AURIX™ TC37x errata sheet

Marking/Step: (E)ES-AA, AA

About this document

Figure 1 Message buffer transfer from Message RAM to OBF

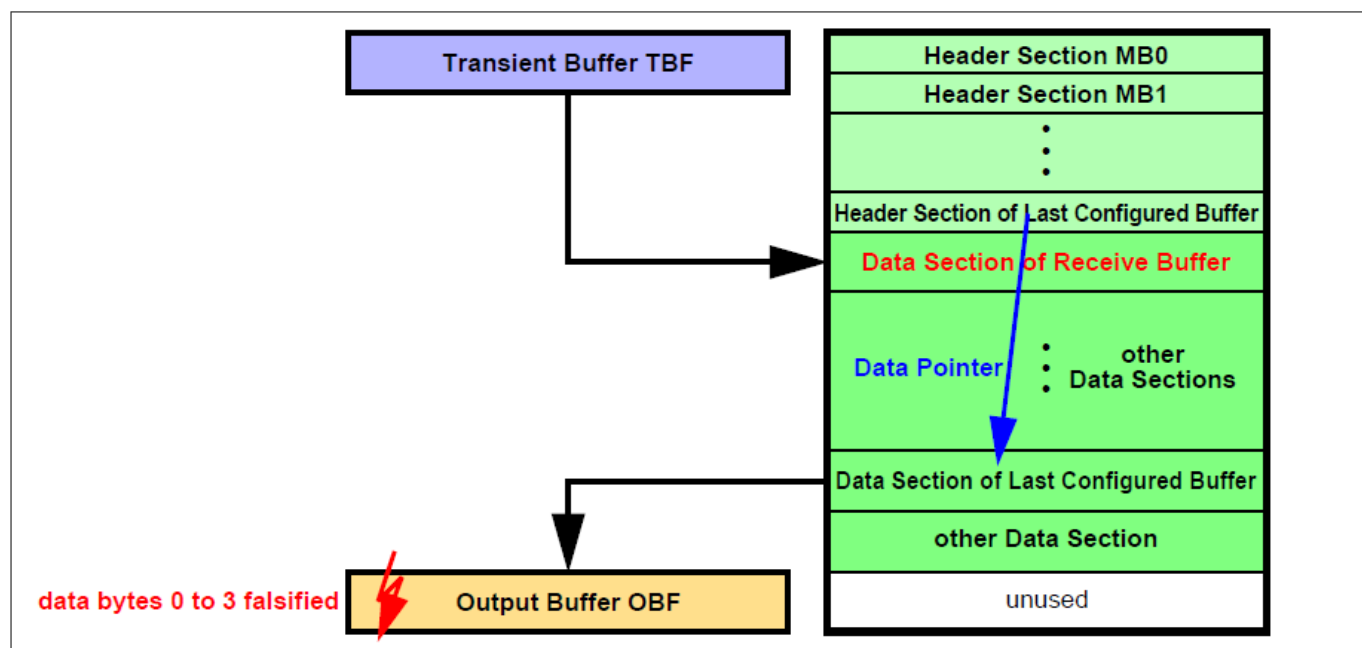
When the message buffer has its payload configured to maximum length (PLC = 127), the OBF word on address 00h (payload data bytes 0 to 3) is overwritten with unexpected data at the end of the transfer.

a) When a message is transferred from the Last Configured Buffer in the Message RAM to the OBF and PLC = 127 it may happen, that at the end of the transfer the OBF word on address 00h (payload data bytes 0 to 3) is overwritten with unexpected data (see [Figure 1](#))

Ensure that the Data Section directly following the Header Partition is assigned to a transmit buffer.

Figure 2 Message buffer transfer from IBF to Message RAM

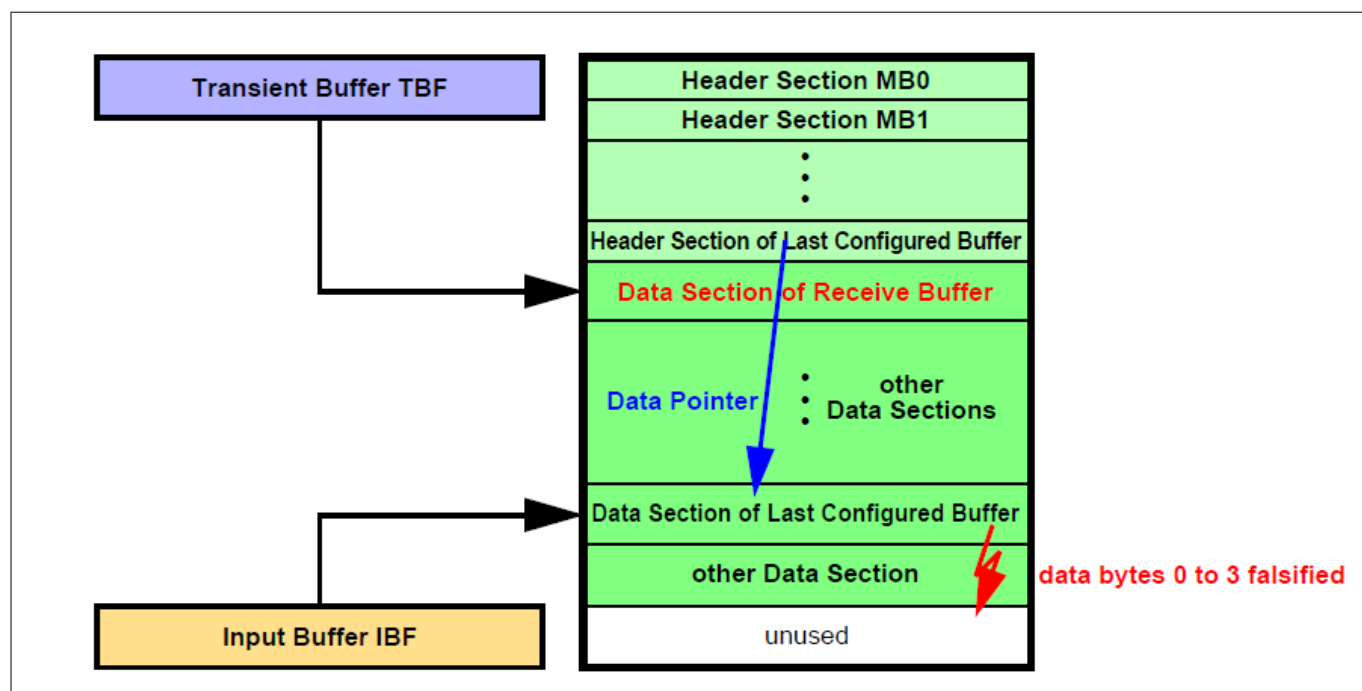
After the Data Section of the selected message buffer in the Message RAM has been written, one additional write access overwrites the following word in the Message RAM which might be the first word of the next Data Section.

b) When a message is transferred from IBF to the Last Configured Buffer in the Message RAM, it may happen, that at the end of the transfer of the Data Section one additional write access overwrites the following word, which may be the first word of another message's Data Section in the Message RAM (see [Figure 2](#))

Figure 3 Message RAM configurations

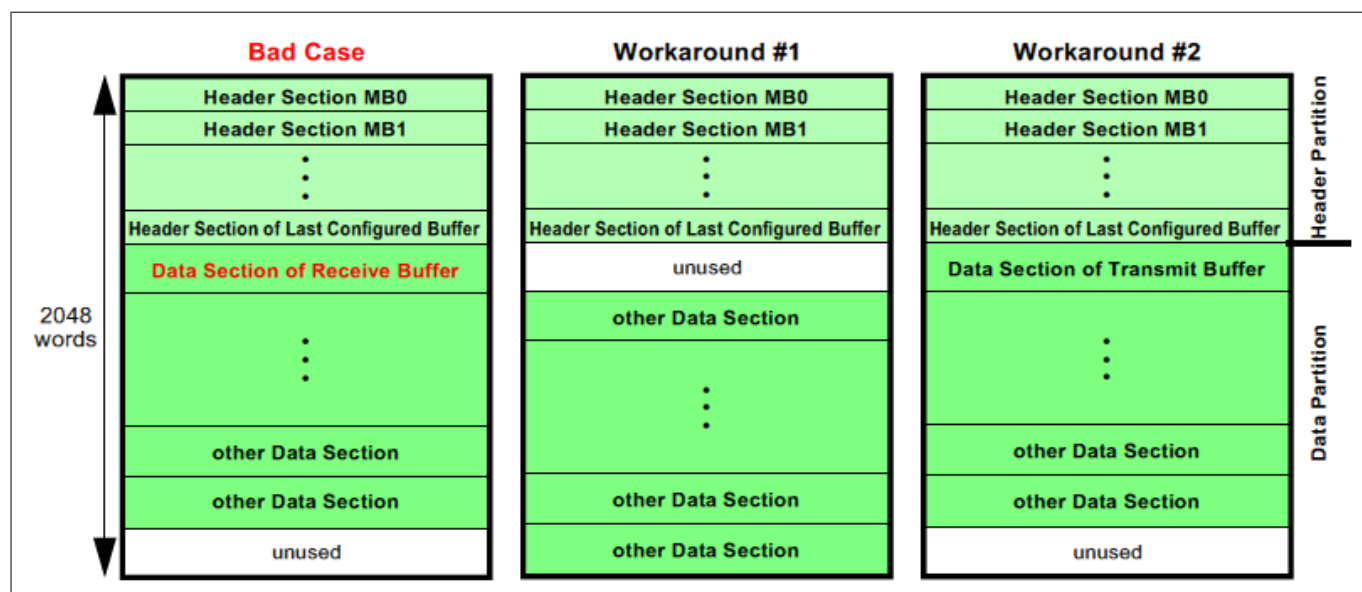
The erratum is limited to the case when (see [Figure 3](#) “Bad Case”):

Figure 4 Cluster-internal AEI network

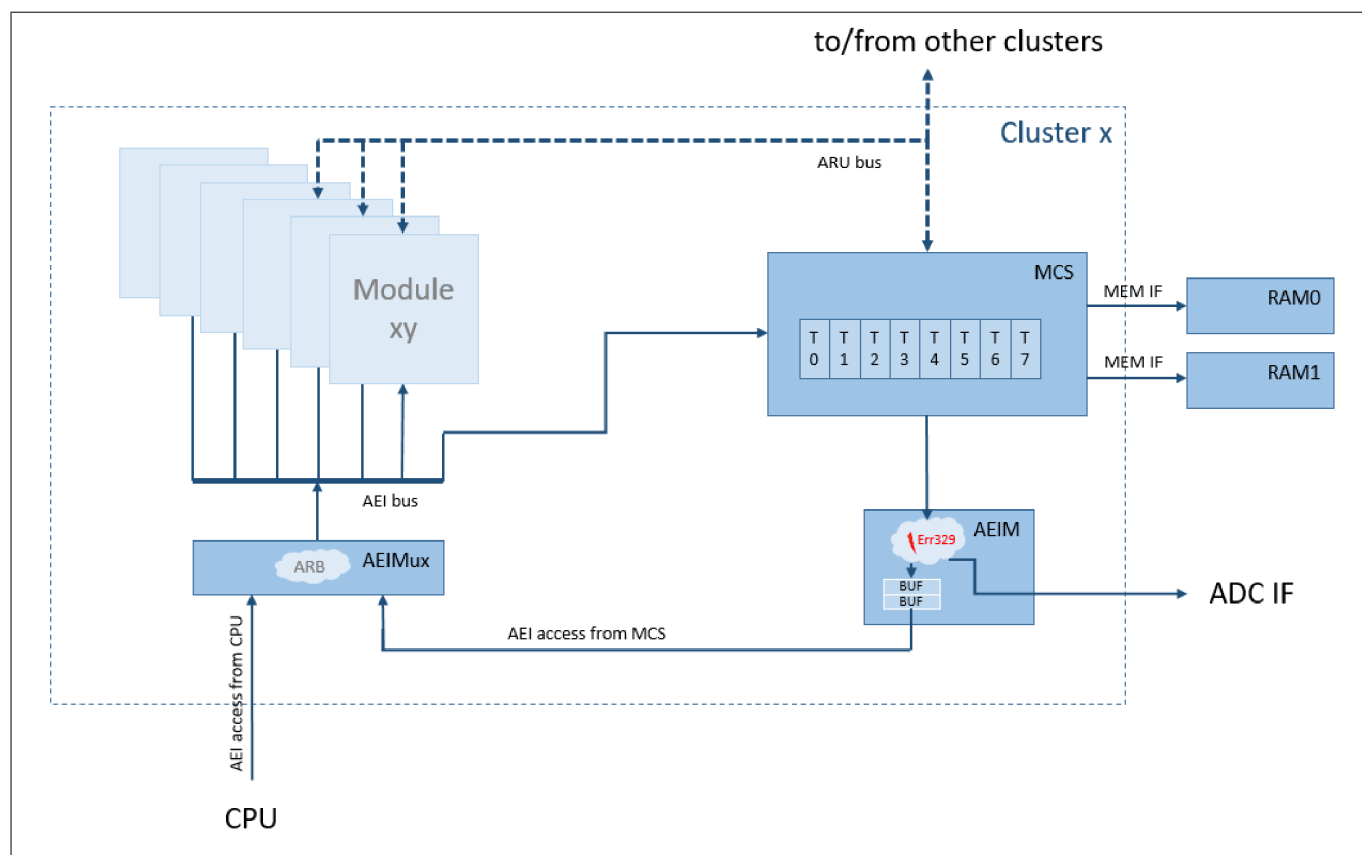
Problem GTM_AI.329 is related to a potential incorrect handling of MCS access requests to the AEI bus at the AEIM entry stage in case that one AEIM buffer is already filled. If in such a case a new access request from MCS enters the AEIM logic during a very specific time window (related to progress on the AEI bus), the AEIM logic might signalize incorrect parameters back to MCS that could result in incorrect data, the loss of data or a repetitive execution of MCS accesses to AEI.

To ensure that a correct execution of MCS channel code is not influenced by certain traffic scenarios on the MCS AEI/ADC bus master interface, only proven usage scenarios are allowed for MCS to AEI/ADC communication. The most common usage scenarios tested to be safe include:

Figure 5 MCS AEI master access path

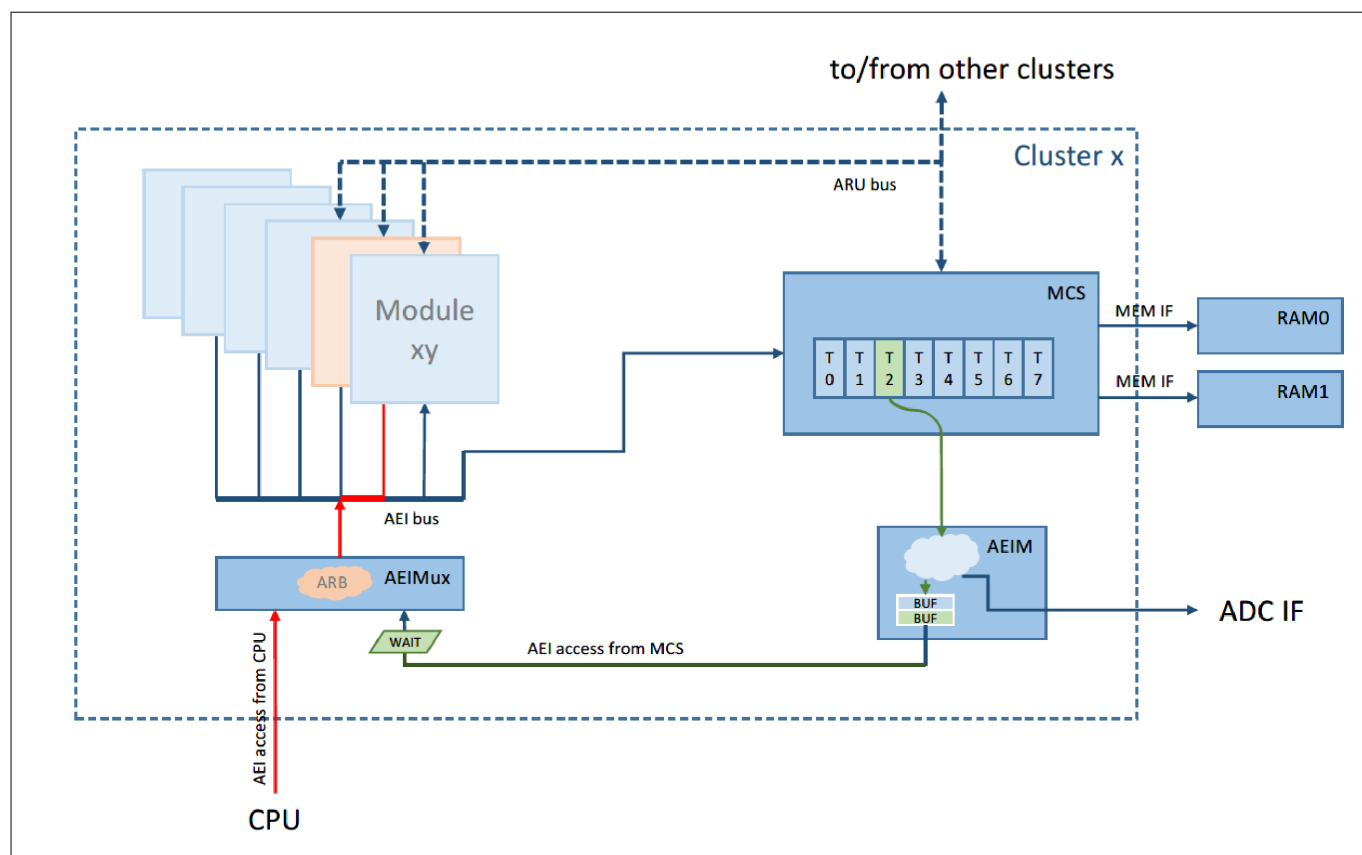
Figure 5 shows an uncritical traffic situation. Here an access of a MCS thread to the AEI bus (green access path) is temporary delayed due to an ongoing AEI bus access from the CPU (red access path). The MCS access to the AEI bus will be safely buffered at the AEIM (green buffer). As soon as the CPU access to the AEI bus completes, the buffered AEI bus access from MCS will be executed.

Figure 6 Critical MCS AEI master scenario

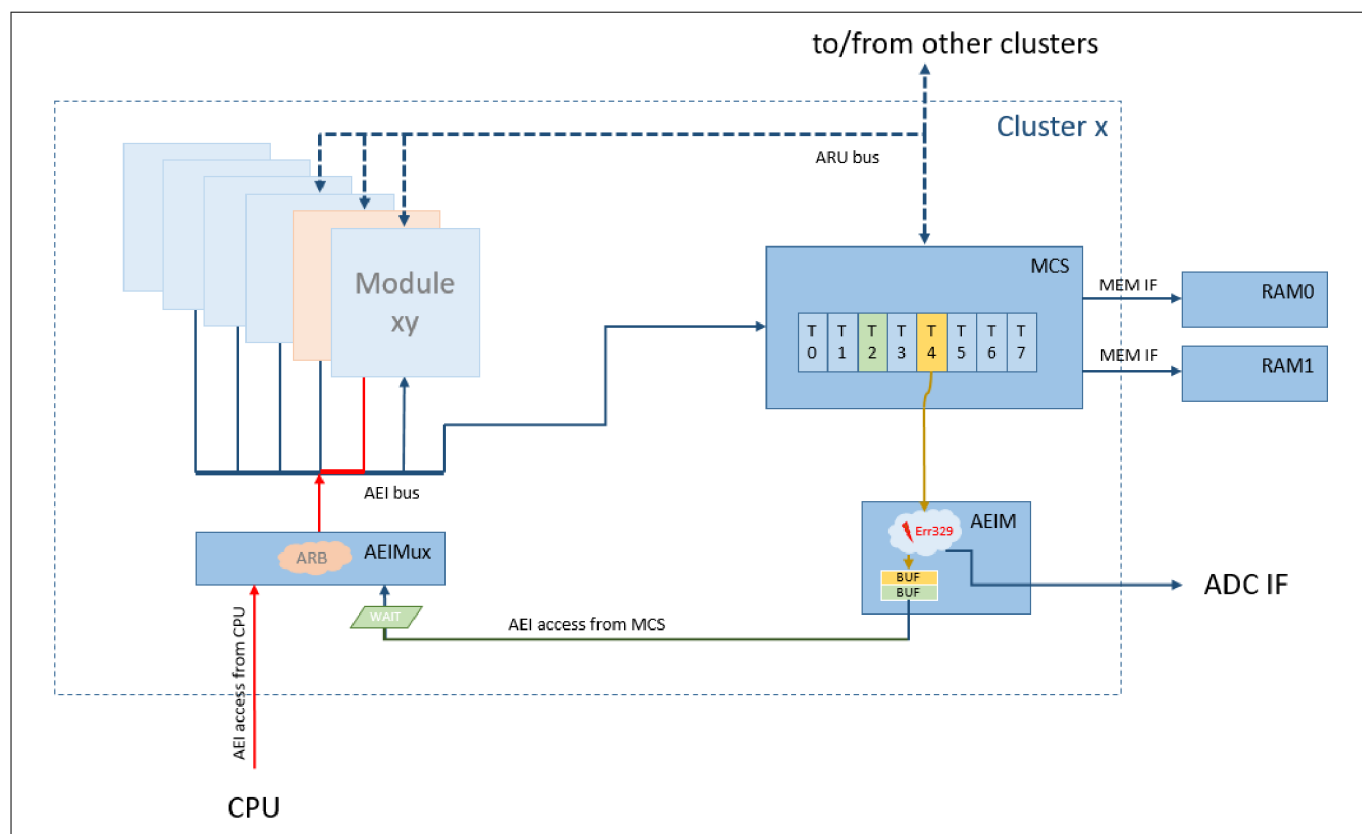
In [Figure 6](#), a potential risk for the occurrence of problem GTM_AI.329 is illustrated. Here the first buffer of the AEIM (green) is still waiting for the access to the AEI bus while a second AEI bus access from MCS arrives at the AEIM (yellow access path). Under certain, but for the user unpredictable timing conditions, this second AEI bus access arriving at the AEIM can trigger the misbehavior described in problem GTM_AI.329.

The workarounds described in the 'Workaround' section will ensure that not more than one AEIM buffer will be filled and therefore the occurrence of problem GTM_AI.329 is avoided. All workarounds have been tested and proven correct.

Figure 7 MCS token mechanism

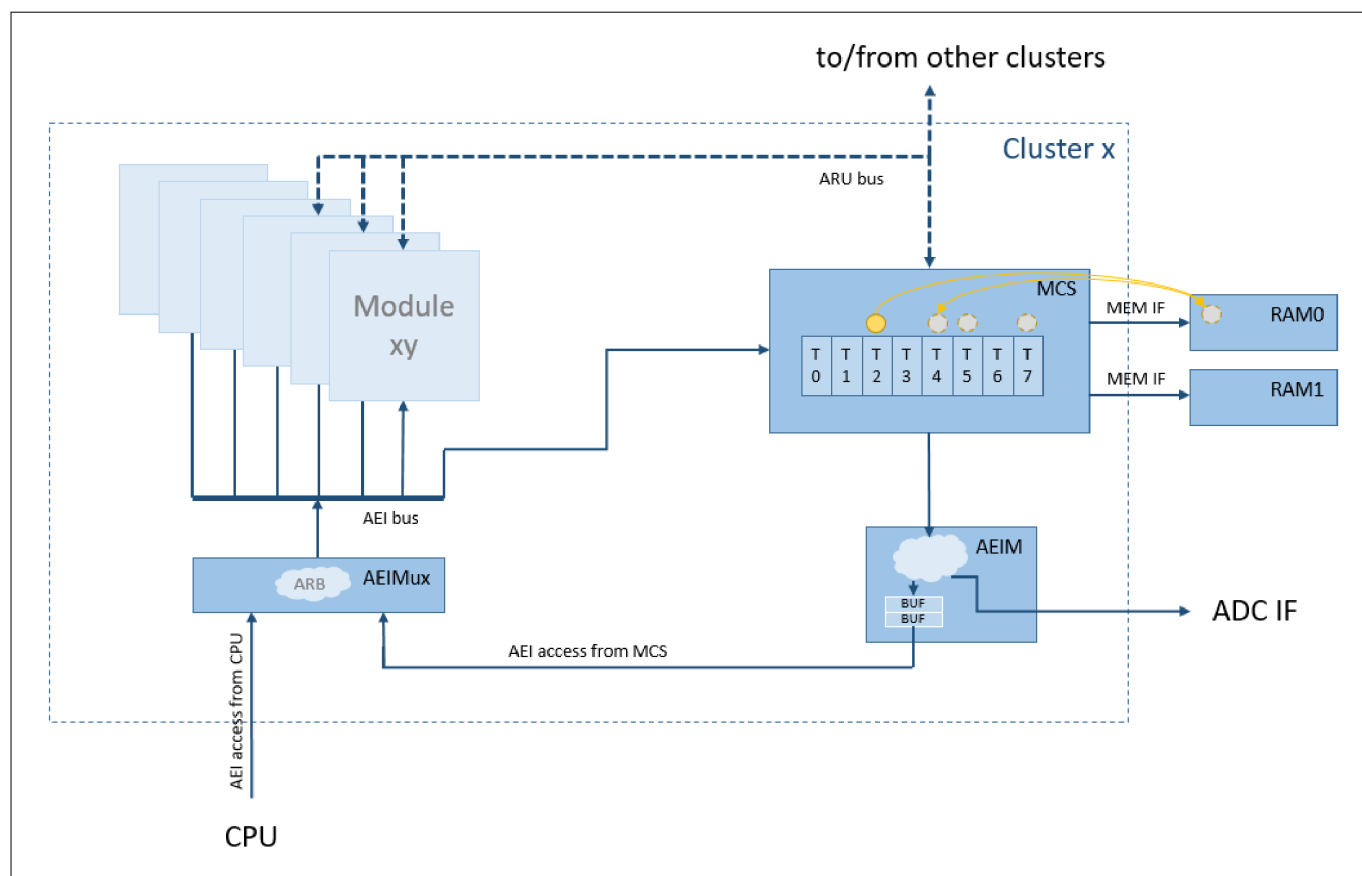
In case multiple MCS channels want to use the AEI master port for AEI or ADC communication, establish a mechanism that ensures that only one channel uses the AEI master at a time (e.g. exchange a token between channels or use trigger registers to hand over the AEI master port ownership between MCS channels).

An application note (AN020 – MCS Mutex implementation) describing a token exchange mechanism between MCS threads is available at Bosch. Such a token mechanism allows multiple MCS threads to safely access the AEI bus system by exchanging an AEI bus access token via MCS memory.

Workaround

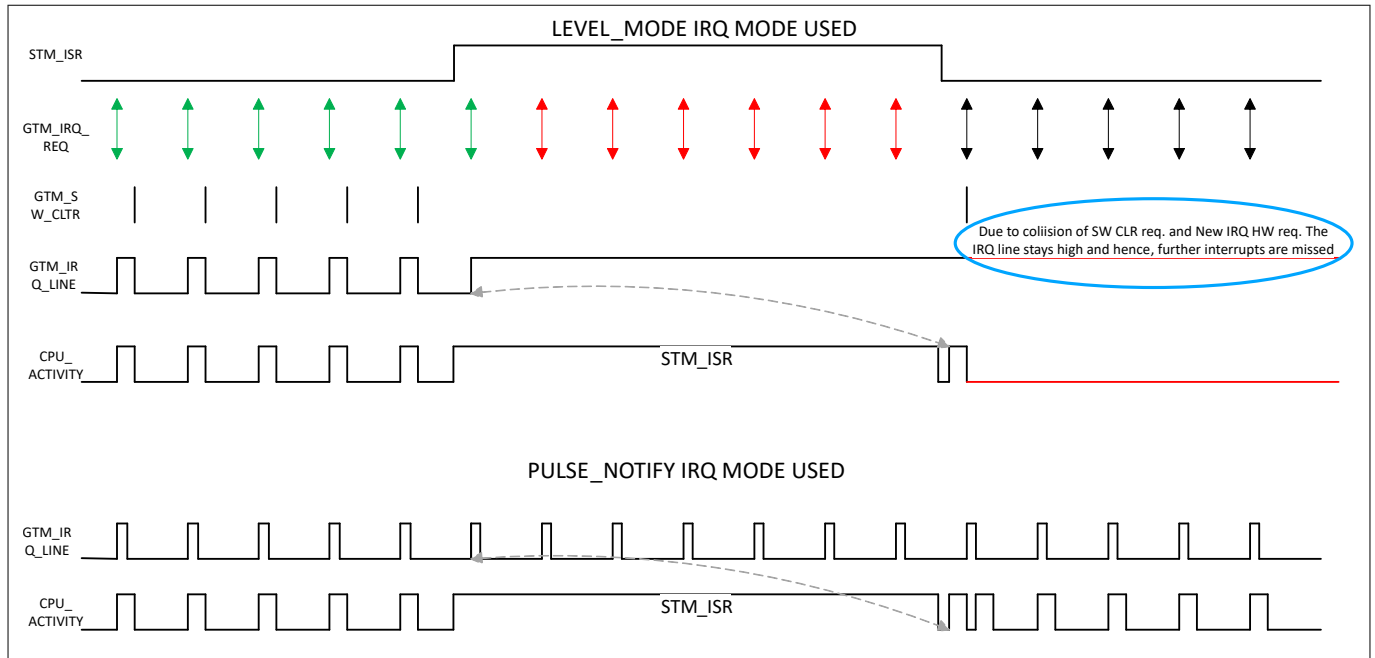
interrupt and clear events), GTM_IRQ_XXX is not cleared and remains high. As a consequence, the IR observes no transition on GTM_IRQ_XX. Thus, any forthcoming interrupt events in this scenario are lost as there is no chance to release the CPU IRQ when a collision happens as shown in Figure below.

If Pulse-Notify mode is selected, every internal trigger will be forwarded to the IR, irrespective of the time of occurrence and the clear event, as the pulse-notify leads to set and reset of GTM_IRQ_XXX as compared to only setting of the GTM_IRQ_XXX line in Level mode.

Figure 12 Timing of LVDS TX interface command sending in relation to IRQ.IFCFS

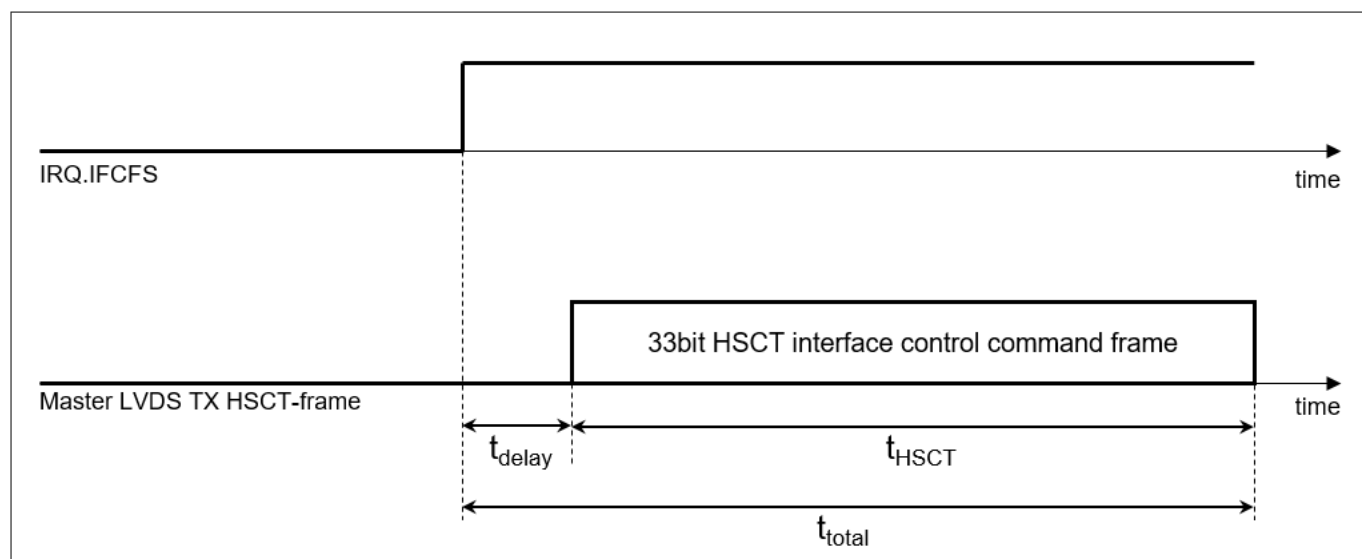
the user might falsely assume that also the actual sending on the LVDS TX port has already occurred once the IRQ.IFCFS flag is set, which is not true.

Instead the timing shown in the following figure applies.
